SUBJECT: ISSUANCE OF AMENDMENT - MILLSTONE NUCLEAR POWER STATION, UNIT NO. 3 (TAC NO. M98699)

The amendment revises the shutdown margin requirements and adds Technical Specification 3/4.3.5 to provide the limiting condition for operation and surveillance requirements for the shutdown margin monitors. The amendment also makes administrative changes and revises the associated Bases section.

SAFETY EVALUATION BY THE OFFICE OF NUCLEAR REACTOR REGULATION

MILLSTONE NUCLEAR POWER STATION, UNIT NO. 3

TS Figures 3.1-1 to 3.1-5

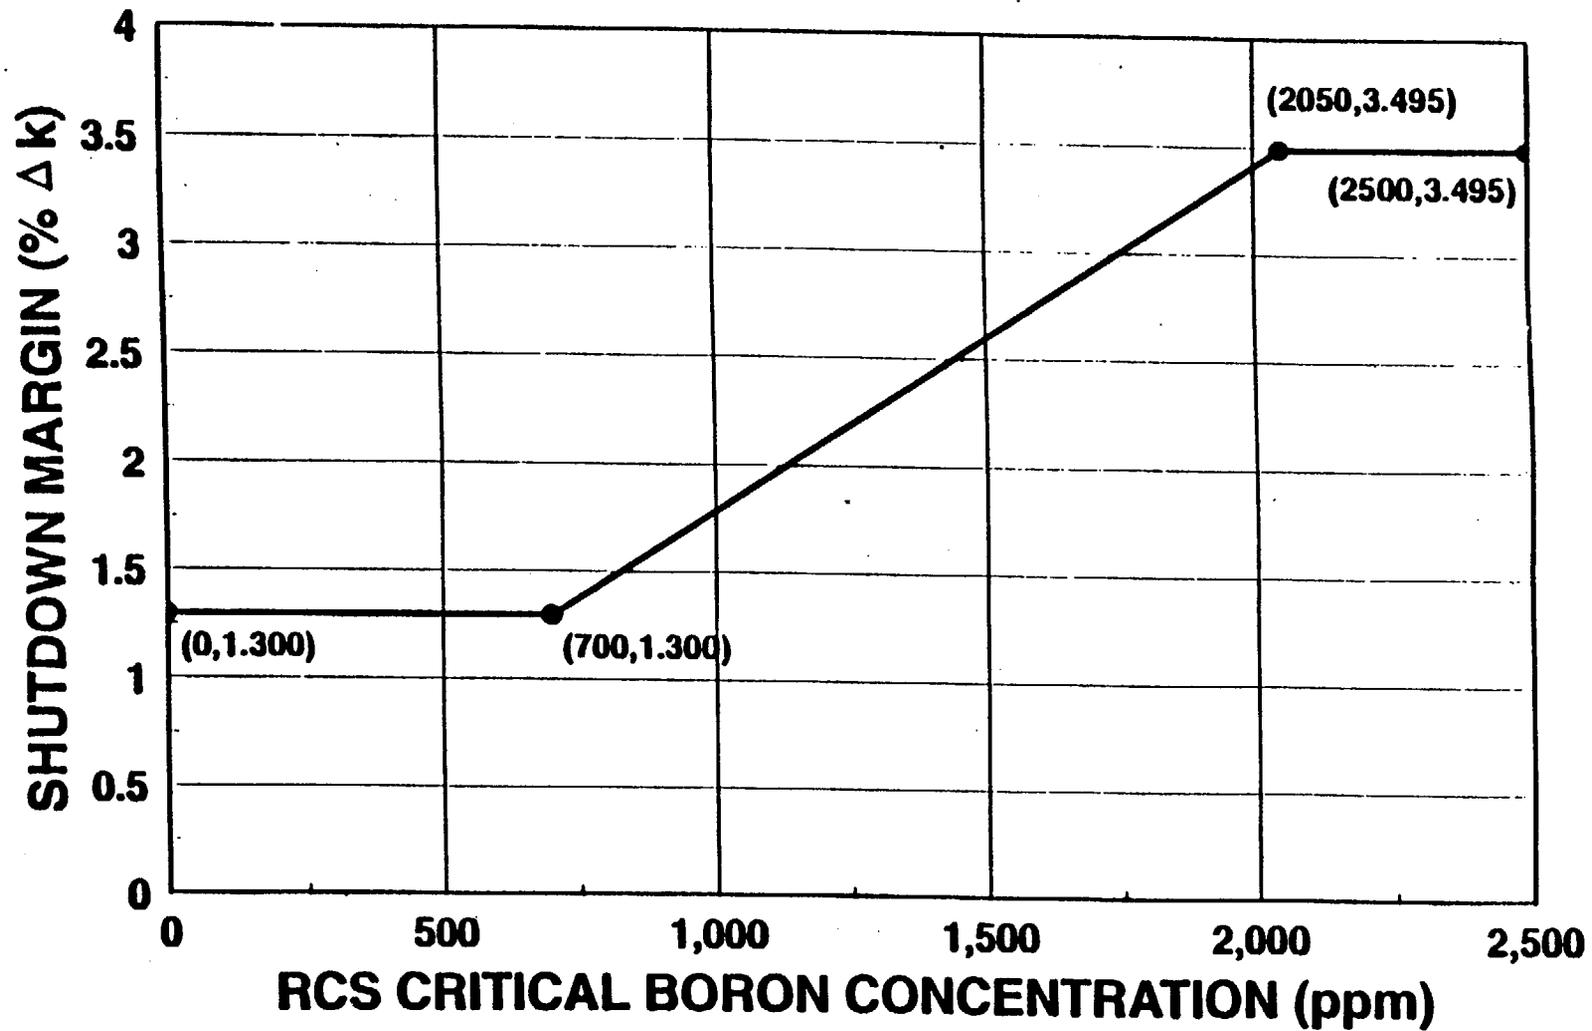
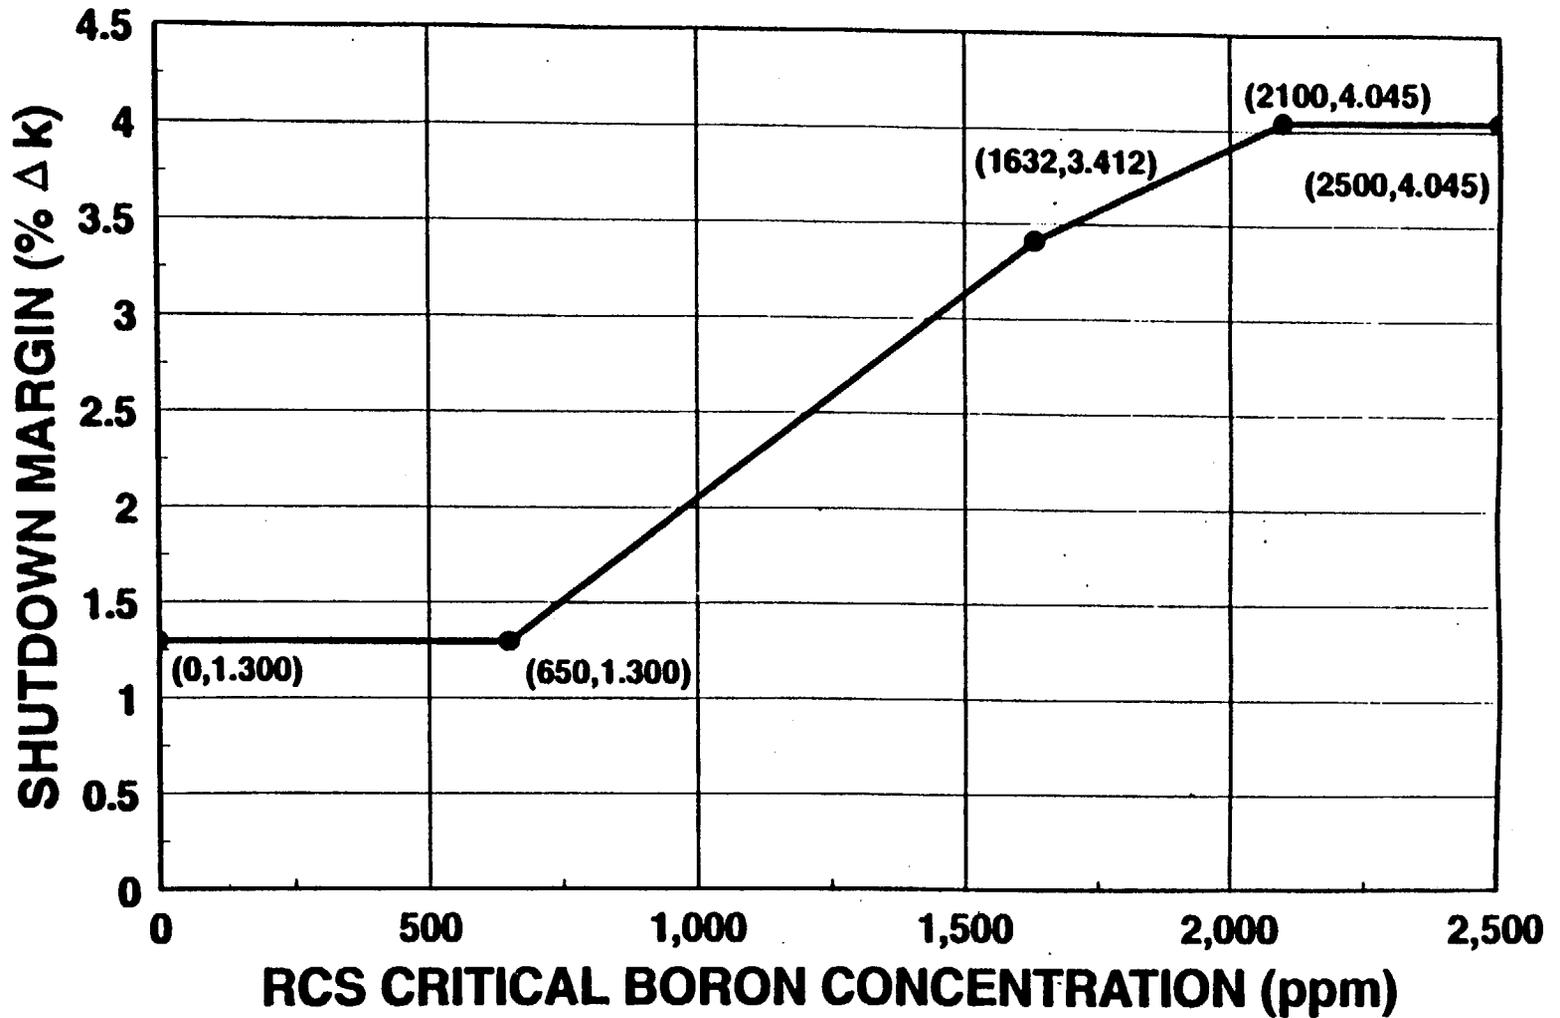
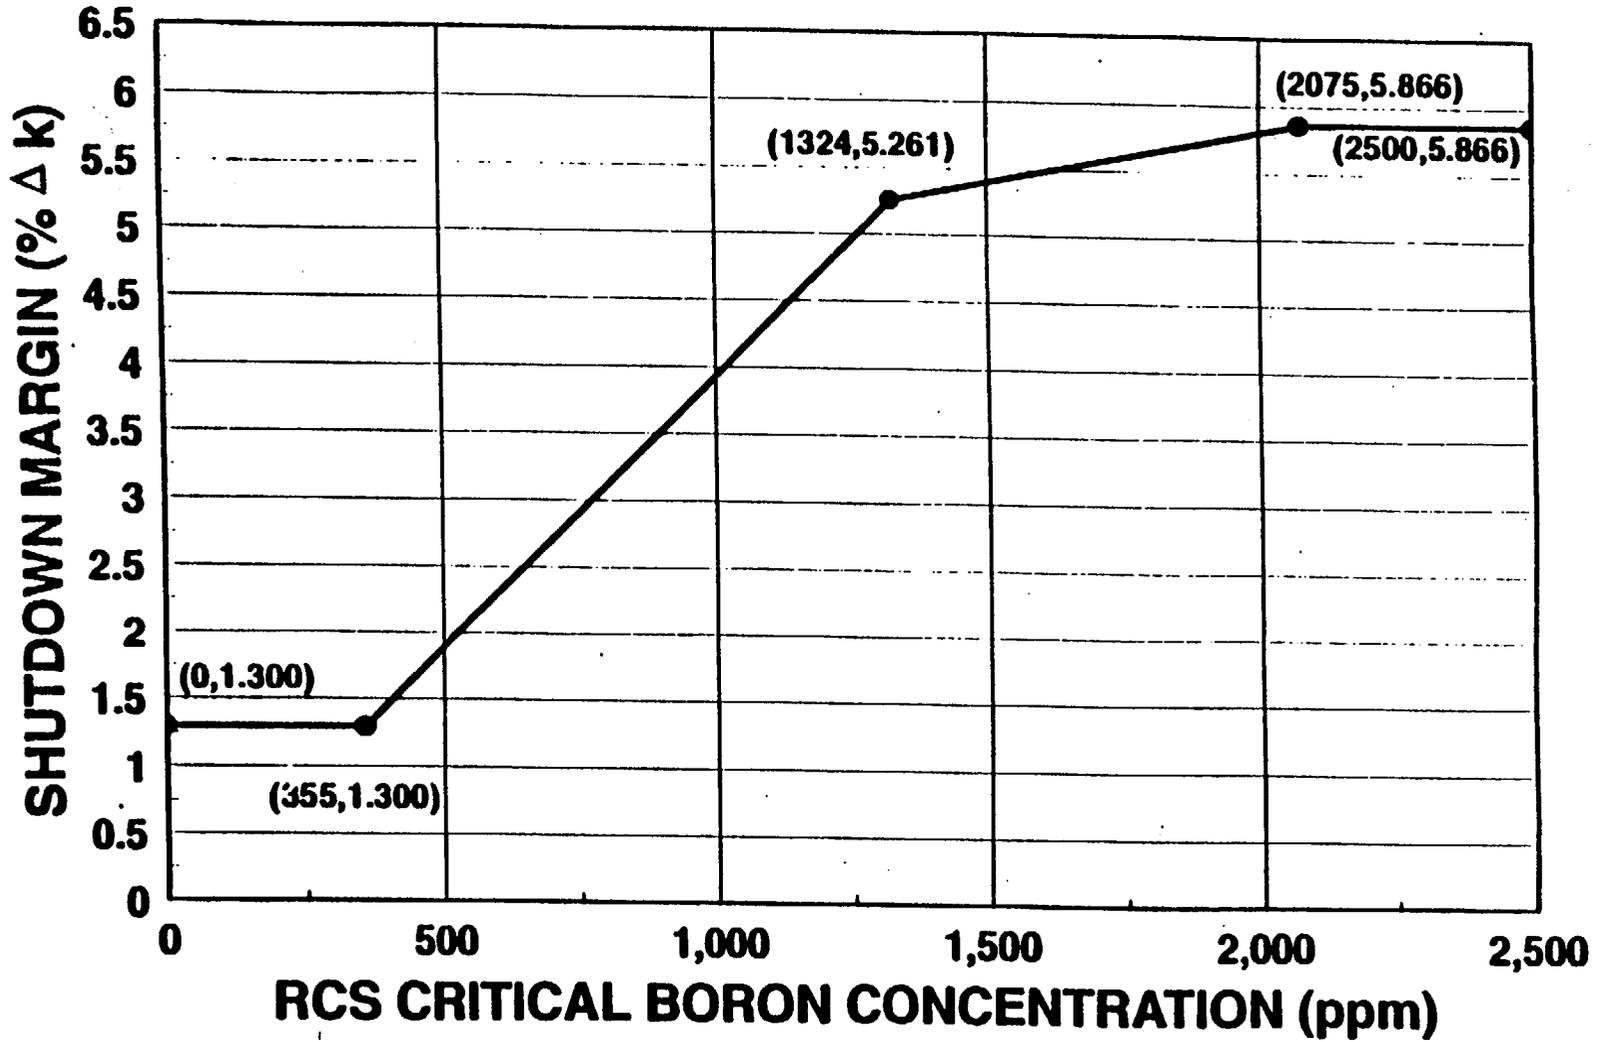
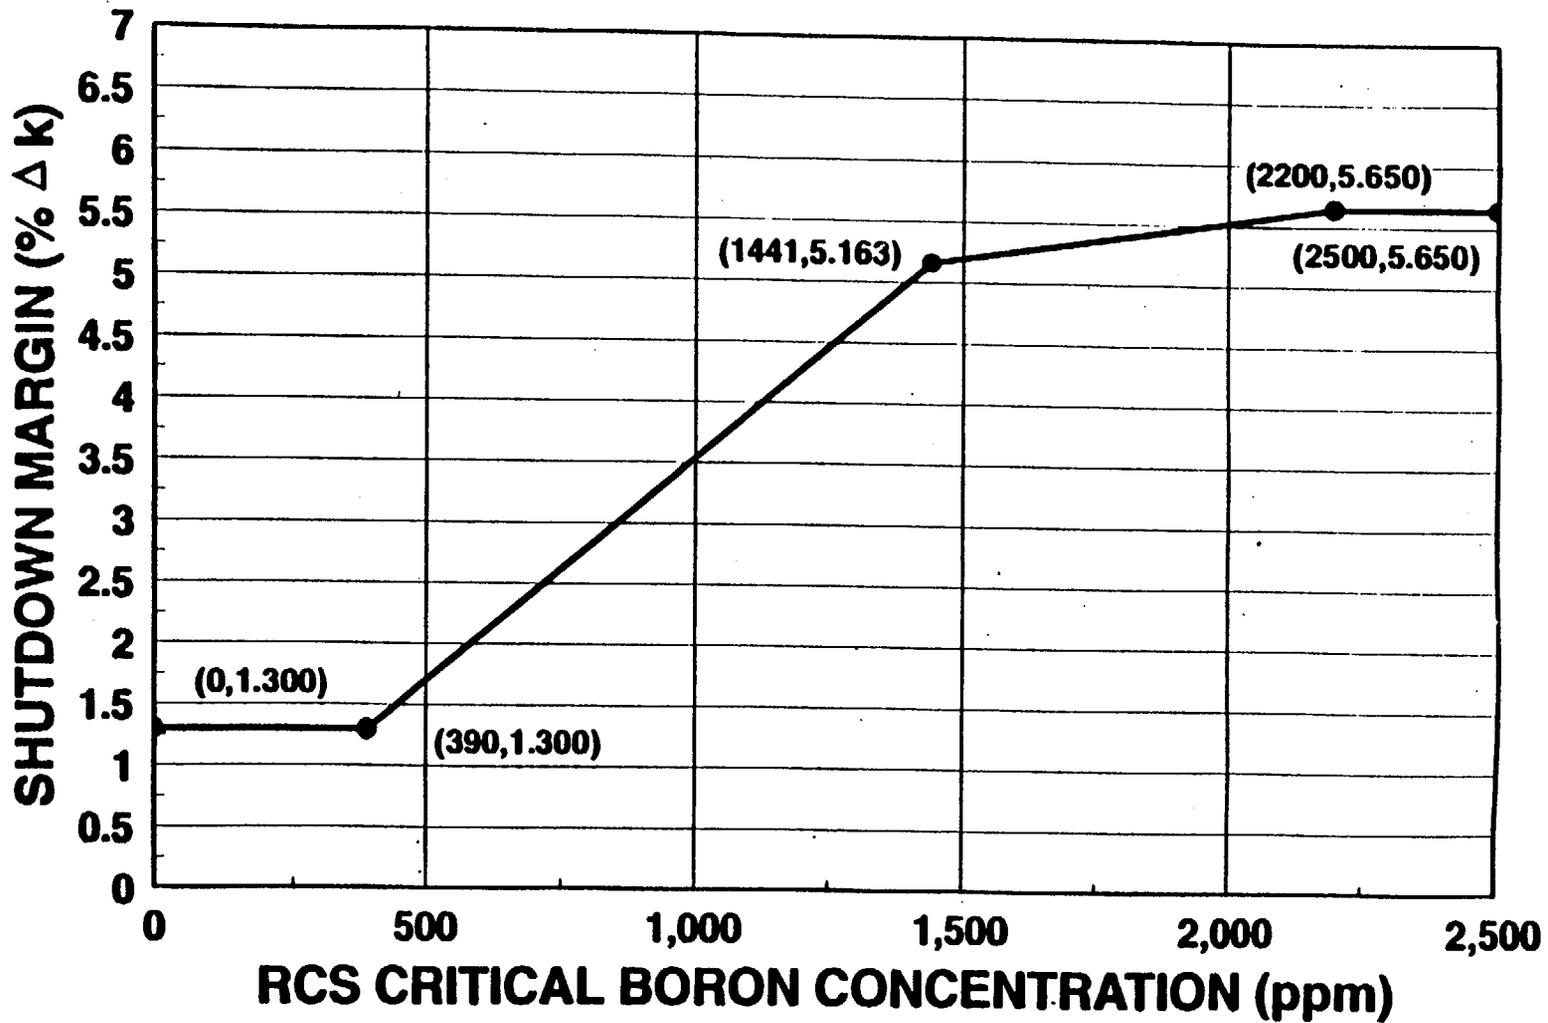
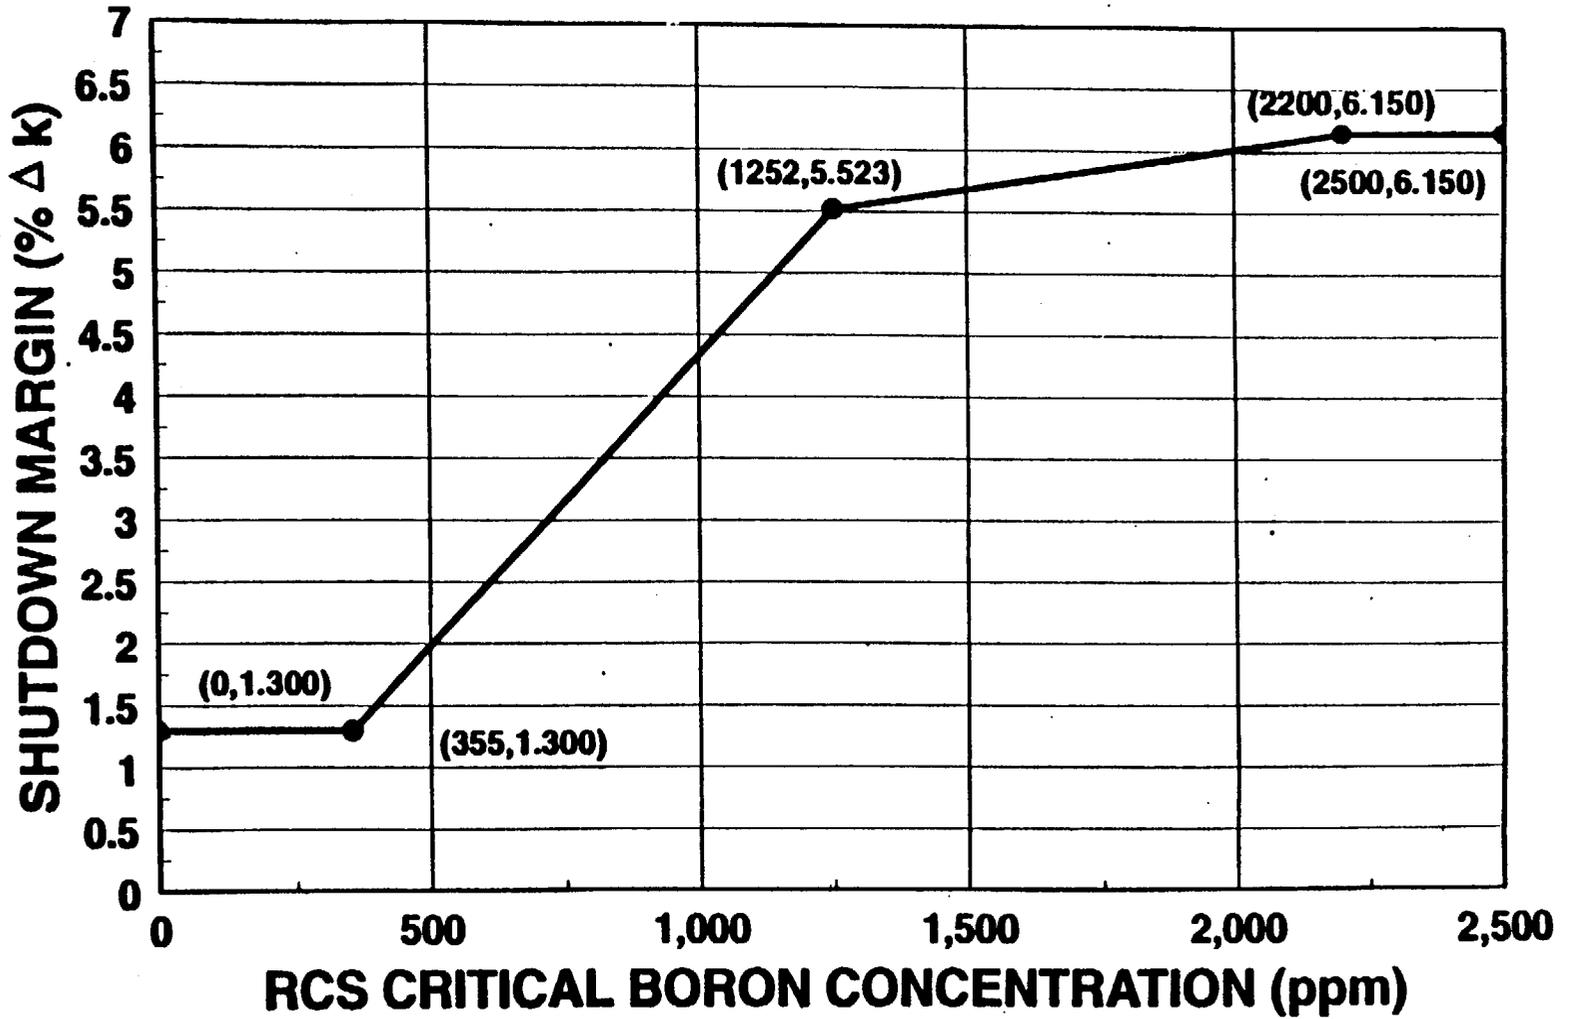
The licensee proposed revised curves based on the reanalyses of the boron dilution event for Modes 3, 4, and 5. The revised shutdown margin/boration requirements are more limiting than the current requirements and they provide operating margin in allowing the SMM to be considered operable at lower initial count rates. The staff finds the revised curves conservative and acceptable.
